BULLETIN #198

## **W41/W55/W56**

### MODIFICATION TO W41-12 PCB

Fig 1, Modifications to W41-12 pcb.

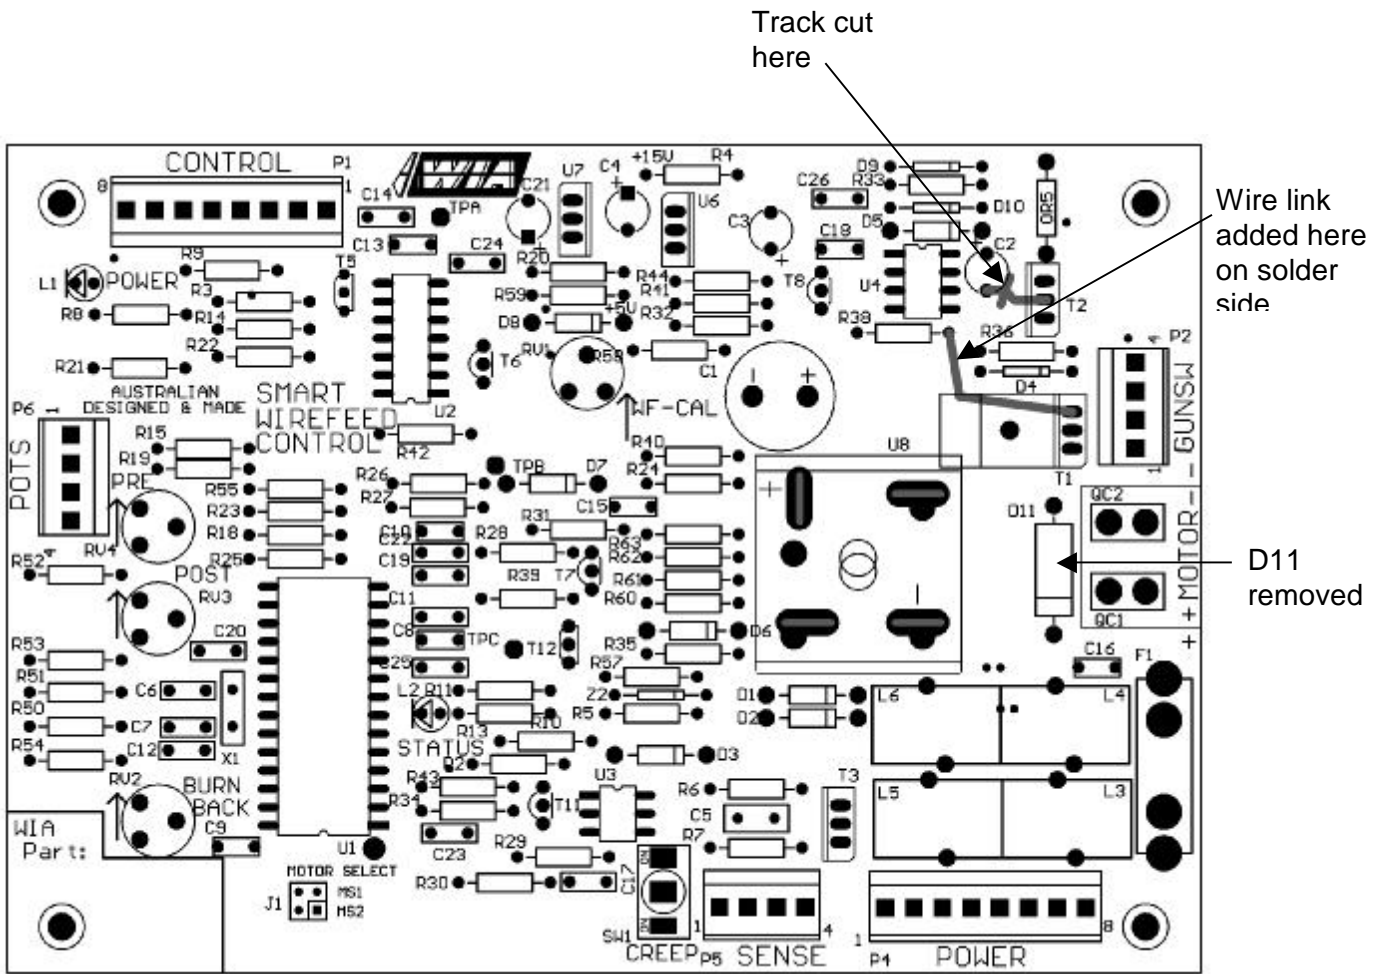
All our stock of the older style pcb were upgraded to an equivalent of the pcb layout change with the following modifications, as per Fig 1, page 2.

- Diode D11 was removed.
- The track which leads from Capacitor C2 –ve to the centre lead of mosfet T2 was cut.
- An insulated wire was added to the solder side of the pcb, connecting the S lead of mosfet T1 to the motor +ve rail (located at the C2 end of resistor R38).
